# STATEMENT OF ENVIRONMENTAL EFFECTS PROPOSED MODIFICATION APPLICATION

FOR RETIREMENT VILLAGE AT 392 GALSTON ROAD  
AND 5 MID DURAL ROAD GALSTON

MARCH 2022

Figure 3: Site Plan

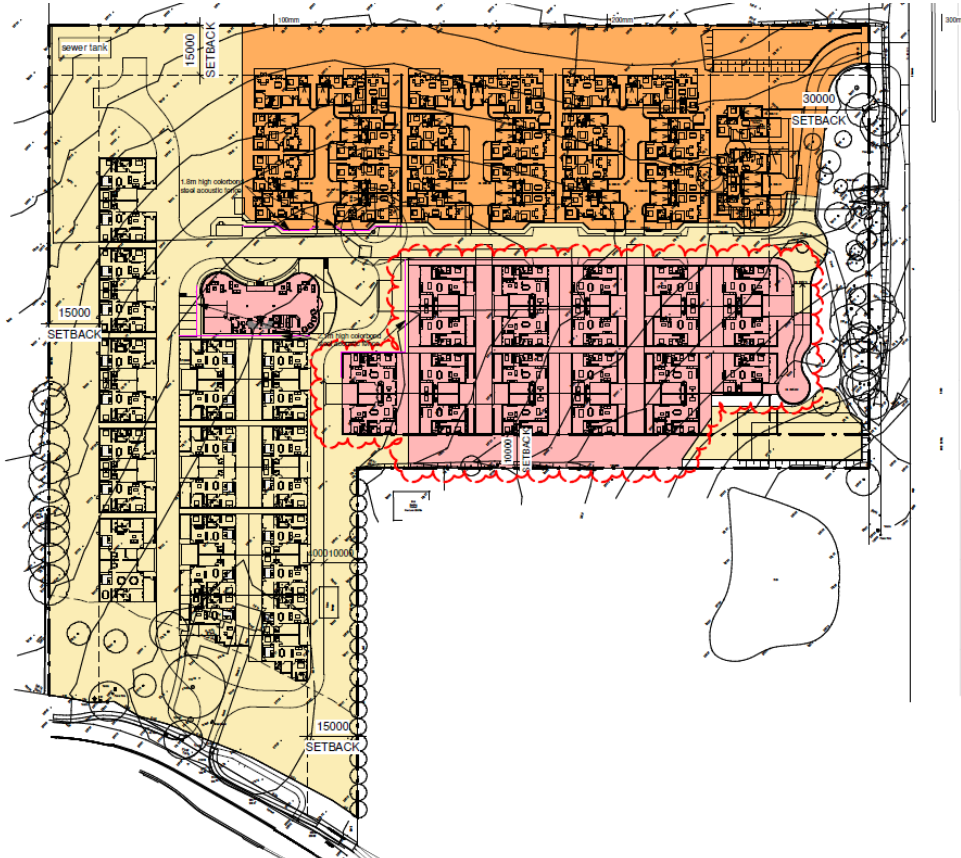
This application seeks consent to modify the design of 21 villas in stage 2, adjust the internal accessway serving the 21 villas, modify the design of the permanent community centre for BASIX and BCA compliance.

Approved Villa 26 to Villa 46

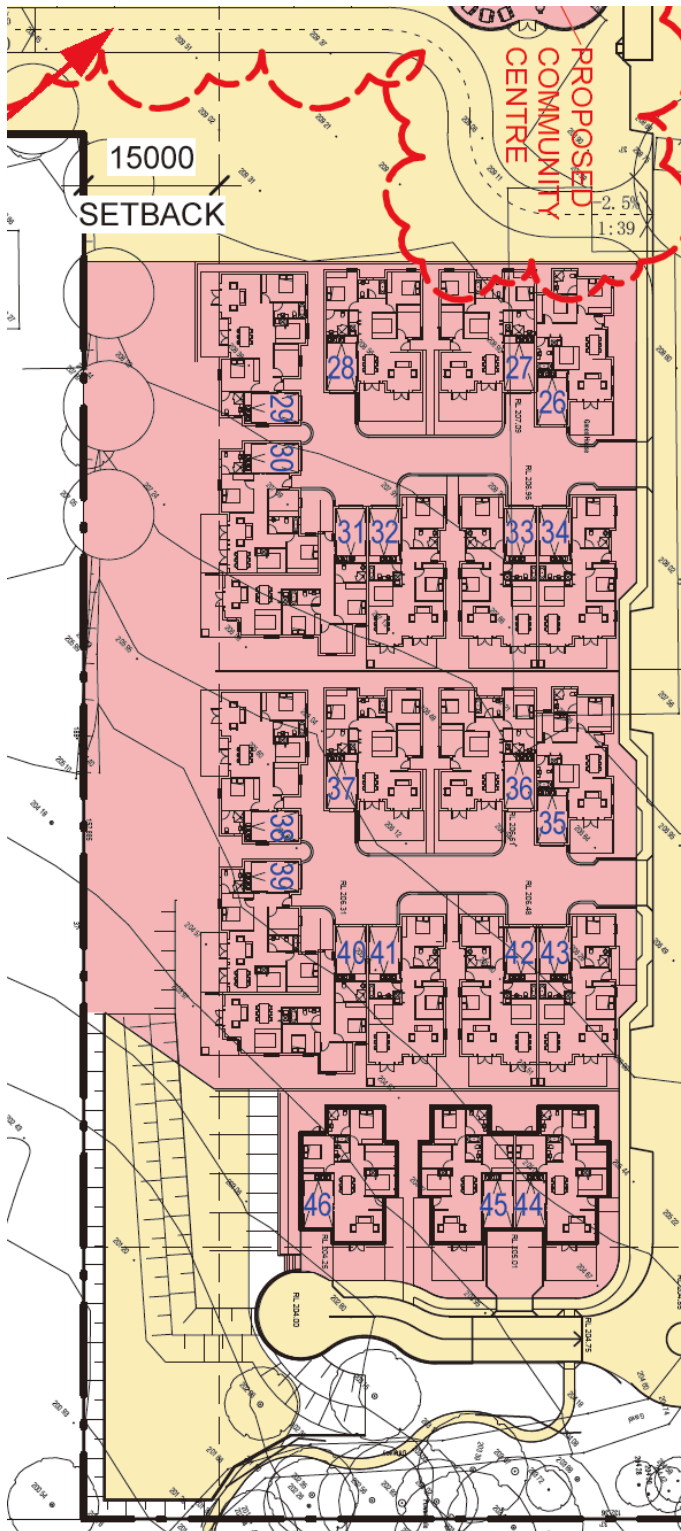
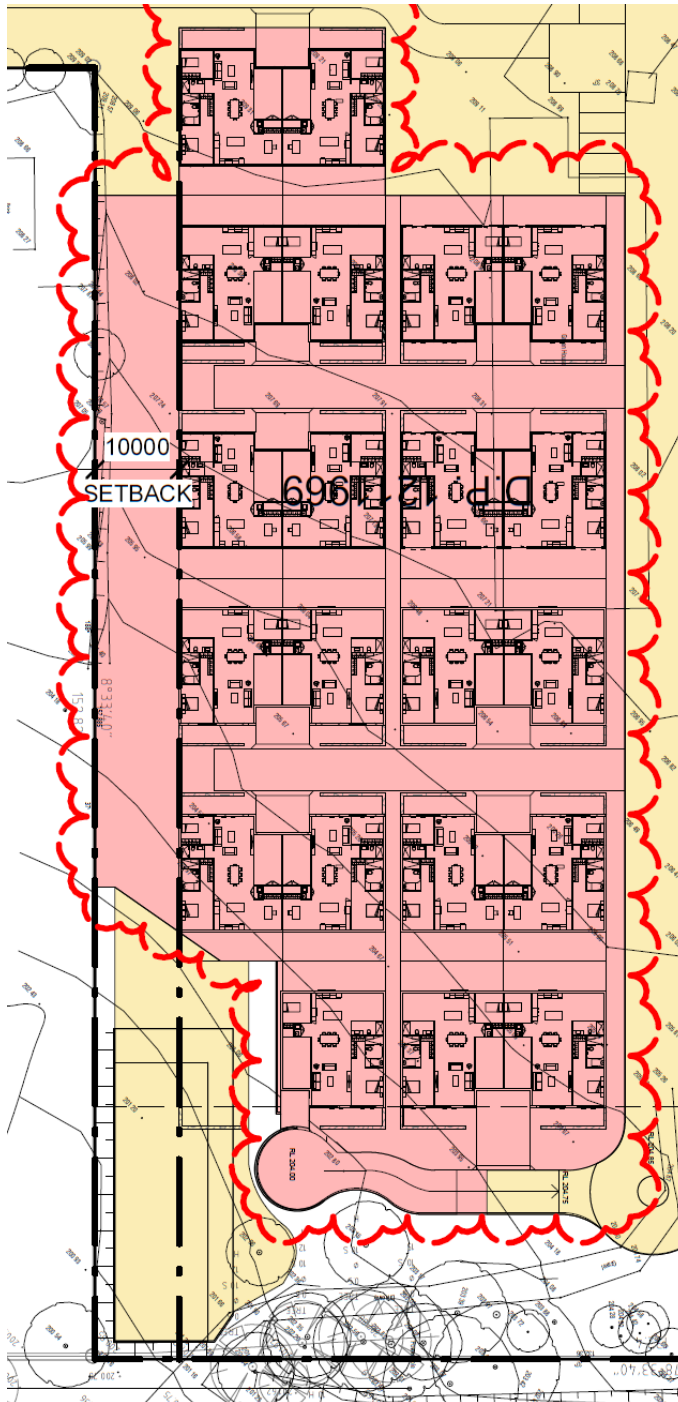
The proposed modifications are limited to villas 26 to 46. The building changes can improve the internal accessibility and provide more circulation spaces. The change of the layout of accessway can provide better privacy and larger backyard for each villa. The detailed modifications are:

- To change layout and driveway access of villas 26 to 43; and
- To change layout of villas 44 to 46.

Villas 26 and 27 will get access from the new internal road serving villas 18 to 25. Villas 28 to 43 will access from the new accessway connecting to the internal road. There is no change to the vehicular access of villas 44 to 46.

The approved villas 29, 30, 38 and 39 located at the end of each accessway are difficult for vehicle access. Residents of villas 29 and 38 need to reverse precisely into their garages to avoid the private yard in front of the garage and another garage door located at one side. Residents of villas 30 and 39 need to reverse out towards other's garage door with great cautious to avoid collisions.

The proposed new design does not have any garages at the end of the accessway. It also provides 6m turning bay at the end to ensure all vehicles will be traveling in a forward direction.

## APPENDIX B

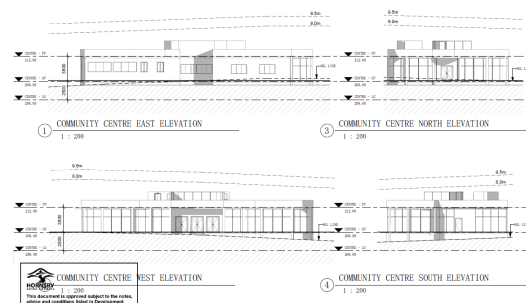
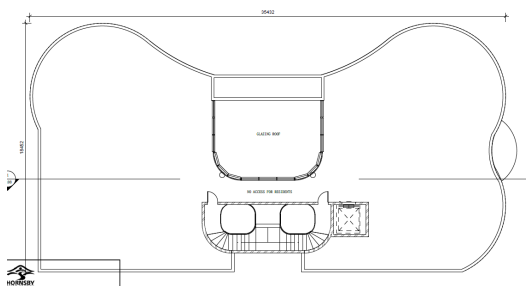
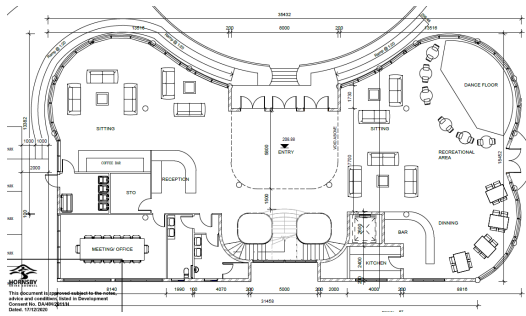
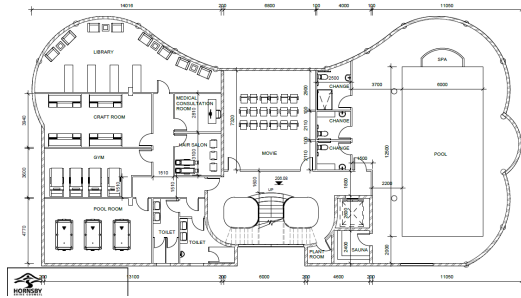
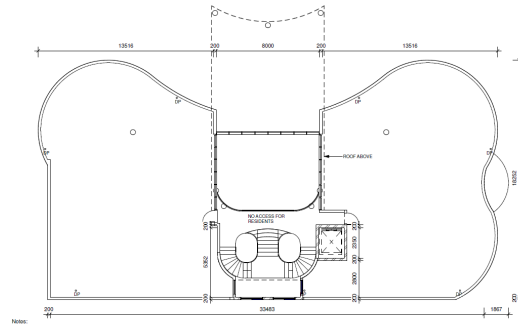
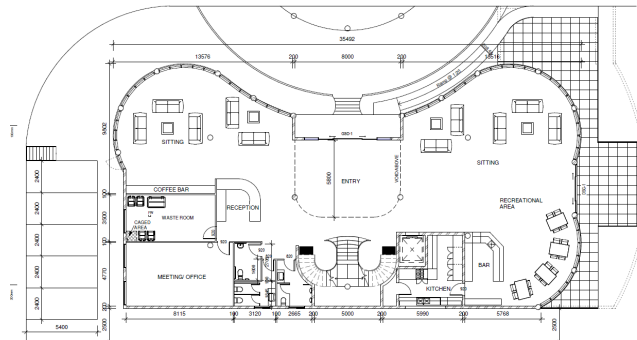
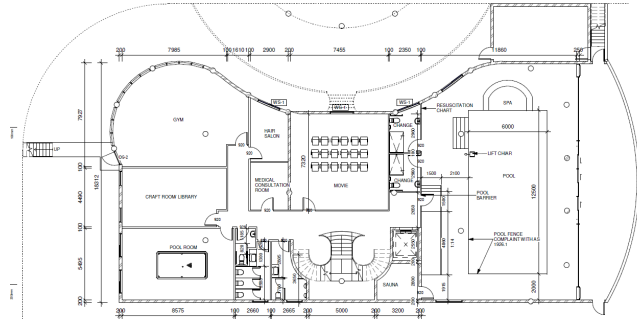
- To achieve NCC compliance, two exits are added to the basement discharging people to the road on the ground level.

- The dance floor on the ground level has been deleted to achieve acoustic requirements. A statement from the acoustic engineer is prepared to verify the changes and support the changes to the consent conditions 27B and 61B by installing acoustic fencing between the community centre and adjacent villas.
- A shading structure is added on the roof plan to comply with the thermo performance requirements.
- Other changes are made to the kitchen, coffee bar, toilets and bathrooms, and room layouts in the basement to improve accessibility.
